Town of Hilton Head Island Regular Design Review Board Meeting

AGENDA

**Town of Hilton Head Island
Design Review Board
Minutes of the Tuesday, February 12, 2013 Meeting
1:15p.m – Benjamin M. Racusin Council Chambers**

A Landscape Plan for:
The FROSTY FROG
Coligny Plaza
Hilton Head Island, South Carolina

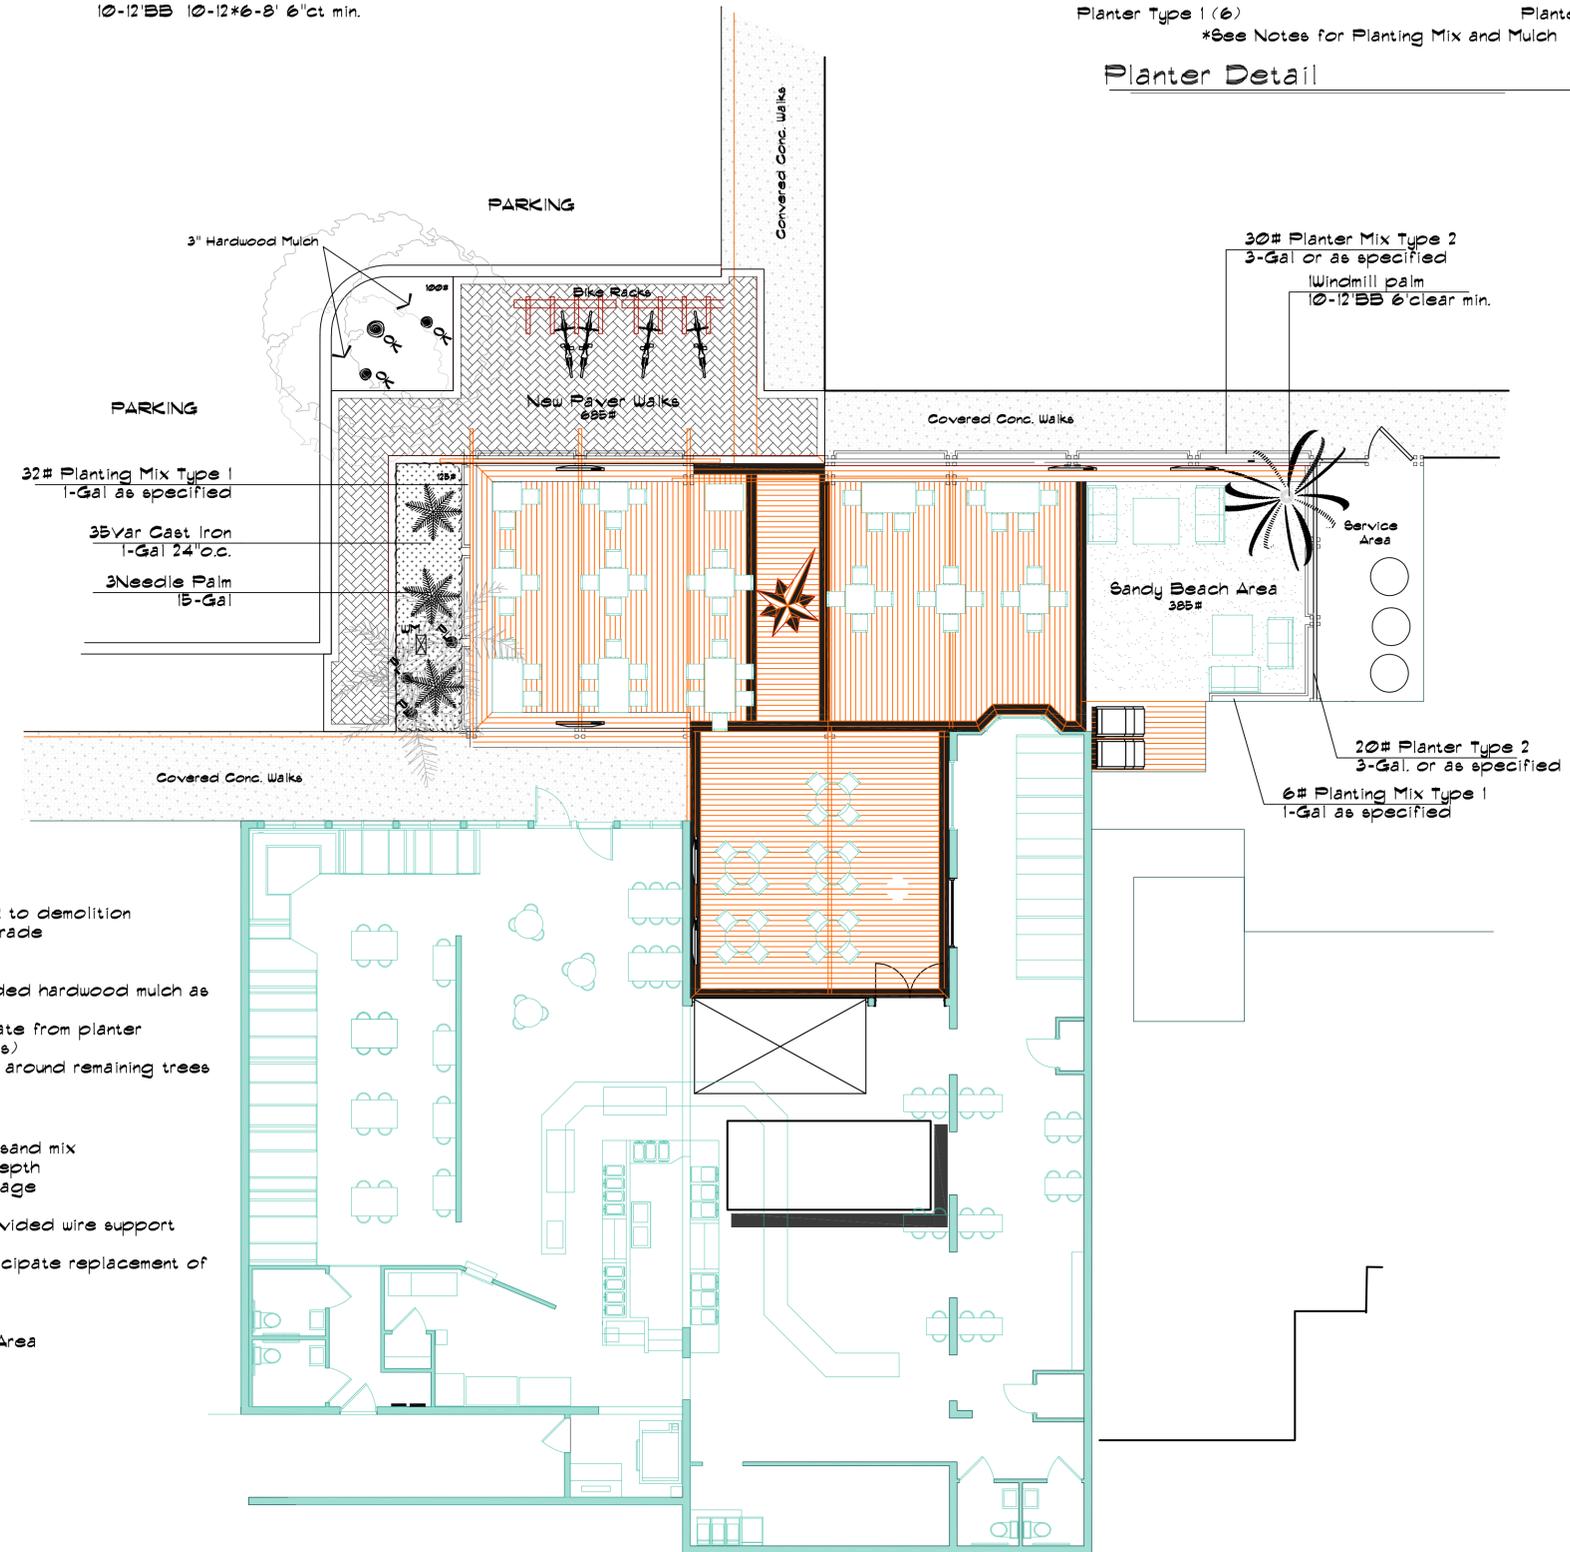
LANDSCAPE DESIGN				
DESIGN GUIDE/LMO CRITERIA	Complies Yes	No	Not Applicable	Comments or Conditions
Treats the Landscape as a major element of the project	<input type="checkbox"/>	<input checked="" type="checkbox"/>	<input type="checkbox"/>	Landscaping is limited to planters (mix of vines and ground cover) and deck adjacent to parking lot.
Provides Landscaping of a scope and size that is in proportion to the scale of the development	<input type="checkbox"/>	<input checked="" type="checkbox"/>	<input type="checkbox"/>	
Landscape is designed so that it may be maintained in its natural shape and size	<input checked="" type="checkbox"/>	<input type="checkbox"/>	<input type="checkbox"/>	Landscaping will require regular maintenance to keep vines growing on green wall.
Preserves a variety of existing native trees and shrubs	<input checked="" type="checkbox"/>	<input type="checkbox"/>	<input type="checkbox"/>

Provides for a harmonious setting for the site's structures, parking areas or other construction	<input type="checkbox"/>	<input checked="" type="checkbox"/>	<input type="checkbox"/>	Plan makes good use of planters where there isn't space for in-ground landscaping.
Location of existing trees and new trees provides street buffers, mitigation for parking lots, and an architectural complement that visually mitigates between parking lots and building(s)	<input checked="" type="checkbox"/>	<input type="checkbox"/>	<input type="checkbox"/>	
Shrubs are selected to complement the natural setting, provide visual interest and screen less desirable elements of the project	<input type="checkbox"/>	<input type="checkbox"/>	<input checked="" type="checkbox"/>	
A variety of species is selected for texture and color	<input checked="" type="checkbox"/>	<input type="checkbox"/>	<input type="checkbox"/>	Lots of variegated plant material

Provides overall order and continuity of the Landscape plan	<input checked="" type="checkbox"/>	<input type="checkbox"/>	<input type="checkbox"/>	
Native plants or plants that have historically been prevalent on the Island are utilized	<input checked="" type="checkbox"/>	<input type="checkbox"/>	<input type="checkbox"/>	
A variety of sizes is selected to create a "layered" appearance for visual interest and a sense of depth	<input type="checkbox"/>	<input type="checkbox"/>	<input checked="" type="checkbox"/>

The location of existing mature trees is taken into account in placement of shrubs so as not to damage tree roots	<input type="checkbox"/>	<input checked="" type="checkbox"/>	<input type="checkbox"/>	
Proper spacing and location for plants to reach their mature size and natural shape while avoiding excessive or unnatural pruning	<input type="checkbox"/>	<input type="checkbox"/>	<input type="checkbox"/>	
Proposed groundcovers are evergreen species with low maintenance needs	<input checked="" type="checkbox"/>	<input type="checkbox"/>	<input type="checkbox"/>	
Large grassed lawn areas encompassing a major portion of the site are avoided	<input checked="" type="checkbox"/>	<input type="checkbox"/>	<input type="checkbox"/>	
The adjacent development is taken into account in determining the most appropriate buffer so as not to depart too dramatically from the neighborhood	<input type="checkbox"/>	<input type="checkbox"/>	<input checked="" type="checkbox"/>
